BROOKHAVEN NATIONAL LABORATORY
ASSOCIATED UNIVERSITIES, INC.

July 25, 1983

This letter report describes the work performed by BNL on the review and evaluation of the buried fuel tanks utilization the Diablo Canyon Plant. The work was completed in May of 1983 and the results were presented in a public meeting held in Bethesda, MD on June 17, 1983.

Fig. 1.a

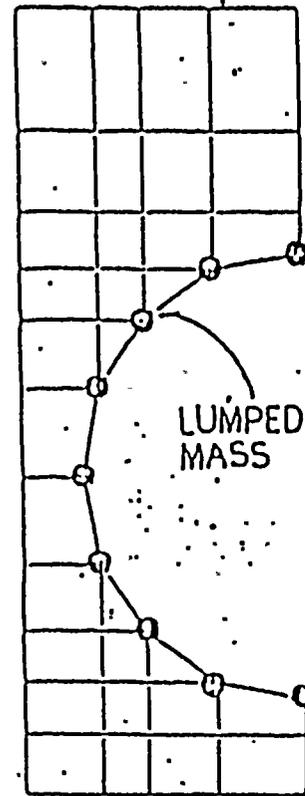
The objective for reviewing the 1978 work was to identify a variety of data, i.e., soil properties, damping values, etc., needed for the subsequent BNL evaluations. The dynamic response of the tanks due to the Newmark-Hosgri event was reviewed on the basis of the 1982 re-analysis results. The FLUSH model of the soil-tank system used by Harding and Lawson in the 1982 re-analysis is shown in Fig. 1a. A lumped mass model was constructed (see Fig. 1b) with the fluid modeled as lumped masses rather than finite elements. The objective for developing this model was to obtain a quantitative appreciation of the effect of the fluid on the seismic response of the tank. Seismic responses due to the Newmark-Hosgri earthquake applied in the horizontal direction using the lumped mass model were obtained with the FLUSH computer program. The results of this analysis are shown in Table 1 together with the corresponding results from the Harding and Lawson 1982 re-analysis. By inspection of the results shown in Table 1, it can be concluded that the results obtained by Harding and Lawson differ significantly from the corresponding results obtained by BNL via the lumped mass model. It was felt that this difference cannot be justified on the basis of the sloshing effect alone which is not included in the lumped model. The sloshing effect would usually be expected to alter the response by 10 to 20%. Sloshing frequencies were calculated and found to be very low, i.e., 0.1 Hz. As such, they should not have important effects on the response of the tank. In view of this, BNL concluded that the significant differences between the Harding and Lawson model and the lumped model constructed by BNL were due to the fluid elements used in the Harding and Lawson model.

In reviewing the computer printout from the FLUSH code, it was observed that the Poisson's ratio value used for the fluid elements was equal to 0.4999, whereas, the instructions in the FLUSH manual clearly state that this value must be below 0.49. Thus, initially it was suspected that this was the problem. In reflecting upon this problem and the flexural ring modes that occur in such a structure, BNL came to the conclusion that such modes could not exist in the Harding and Lawson model because of the inappropriate fluid modeling. Specifically, as a result of the finite element discretization used by Harding and Lawson, the fluid is not allowed to perform its natural motion. Results from a finer grid indeed, proved this BNL position.

Fig. 2

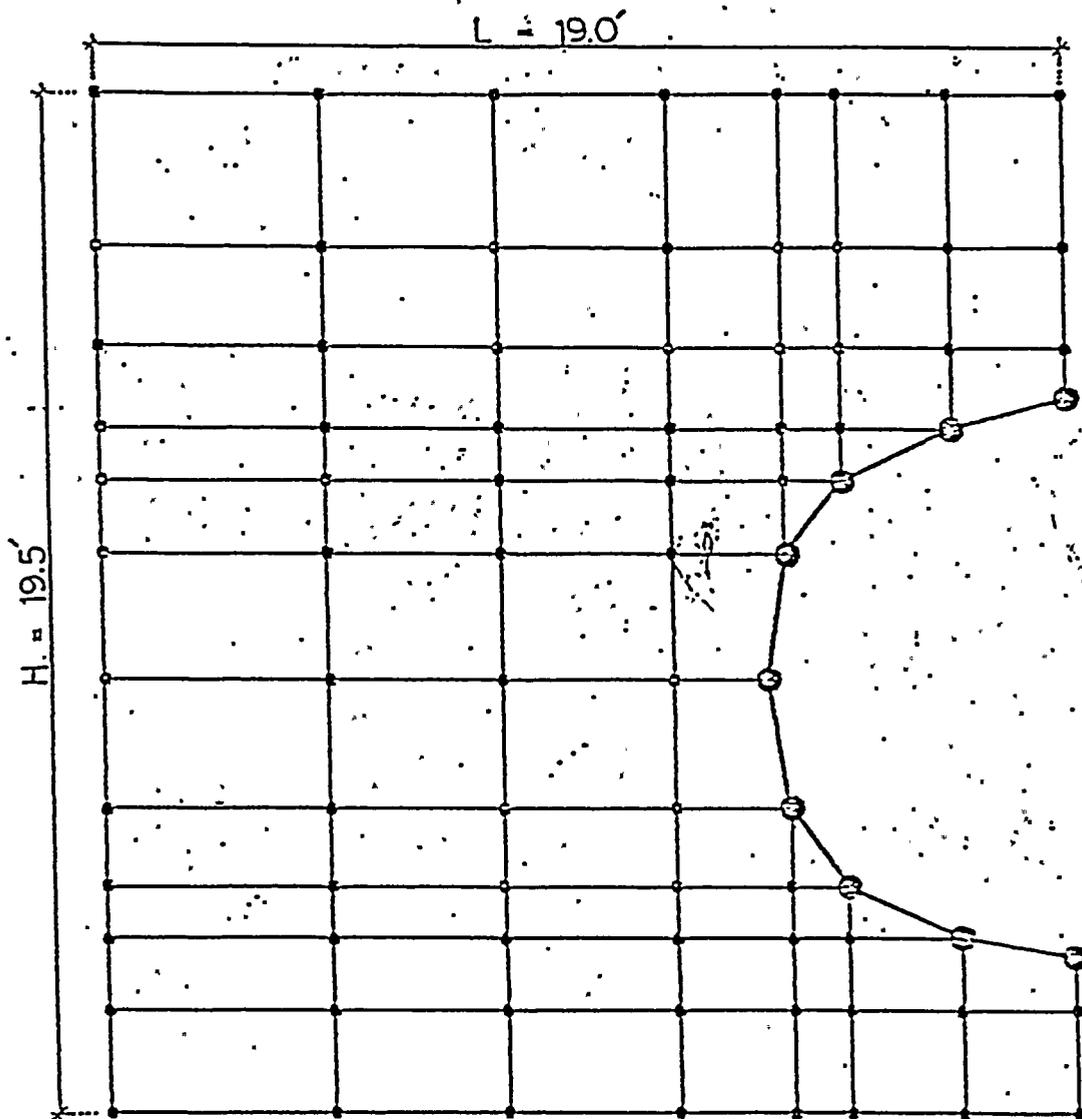
The FLUSH model, shown in Fig. 2, was used for the response evaluation of the soil-tank system normal to the tank axis (transverse response). Inside the trench, it was decided to construct the model in a similar fashion to the one used by Harding and Lawson (Z-Z section) for the 1982 re-analysis. The major difference, however, was that the mass of the oil was lumped at the walls of the tank. This approach although, somewhat conservative, was found to be more appropriate than that of the fluid element idealization employed in the 1982 re-analysis model by Harding and Lawson. Furthermore, in the BNL model, the transmitting boundaries were moved further away from the tank walls. This was done to avoid possible reflections at the boundaries.

Fig. 3

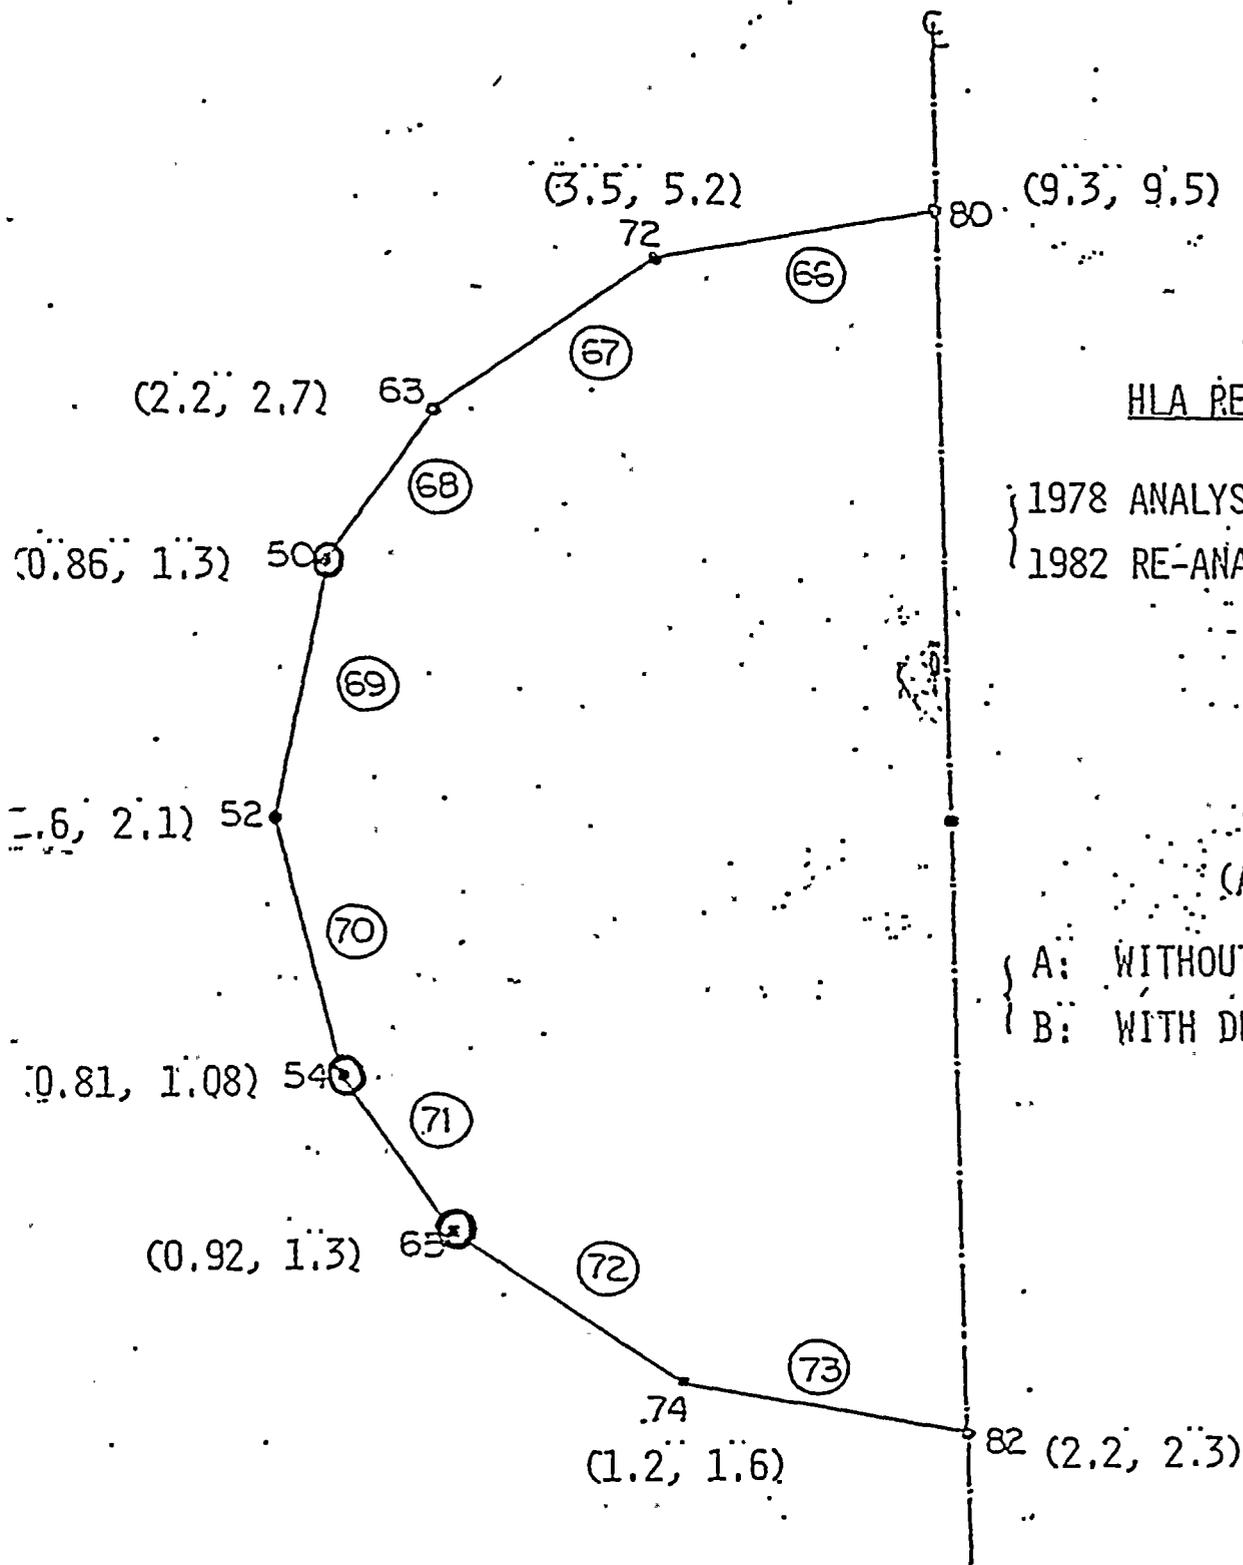
seismic stresses obtained by BNL were then combined with the static stresses given by Harding and Lawson in their 1982 static re-analysis. Based on the total stresses (i.e., static dynamic) safety factors were computed. In evaluating the safety factors the same approach as that used in the 1982 re-analysis was employed. These safety factors are depicted in Fig. 3.

Fig. 4

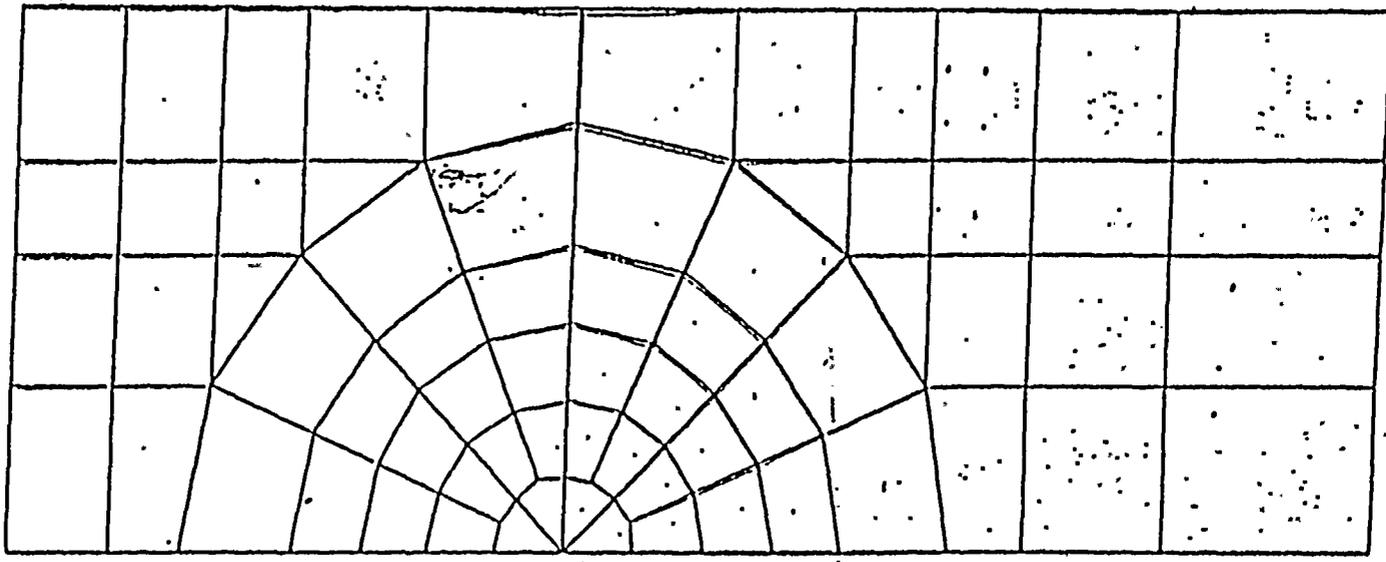
The BNL refined FLUSH model is shown in Fig. 4. This model was essentially constructed from the Harding and Lawson 1982 re-analysis model. The finite element grid of the fluid, however, was as can be seen substantially, refined. Two types of soil properties were assigned to the model. These are the ZZ and YY section properties.

Soil structure interaction evaluations were performed in the horizontal direction only. These were felt to be sufficient to prove the BNL contention regarding the modeling problem associated with the Harding and Lawson 1982 analysis model. Two sets of runs were made using the ZZ and YY section soil properties. Results are summarized in Tables 2, 3 and 4. From these it is clear that the refined model results are closer to the corresponding lumped model results. It is also fairly clear that the Harding and Lawson 1982 model differs significantly from both the refined and the lumped model. Furthermore, the responses from the YY model indicated that this model is more criti-

ical than the ZZ model. From very limited investigation, it also seems that even higher response would result if YY section properties were to be used together with deconvolution. Finally, initial computer runs made with partially filled tanks also resulted in higher response values. In these initial studies, the partially filled tank was simulated by using the model described in Fig. 4 and by assigning very low stiffness values to the top fluid layer so that it approximated a 90% filled case. For such a case, the bending, particularly, at the top portion of the tank increases. The reason for this is that due to the upward motion of the fluid inside the tank there is less fluid resistance to the tank deformations.
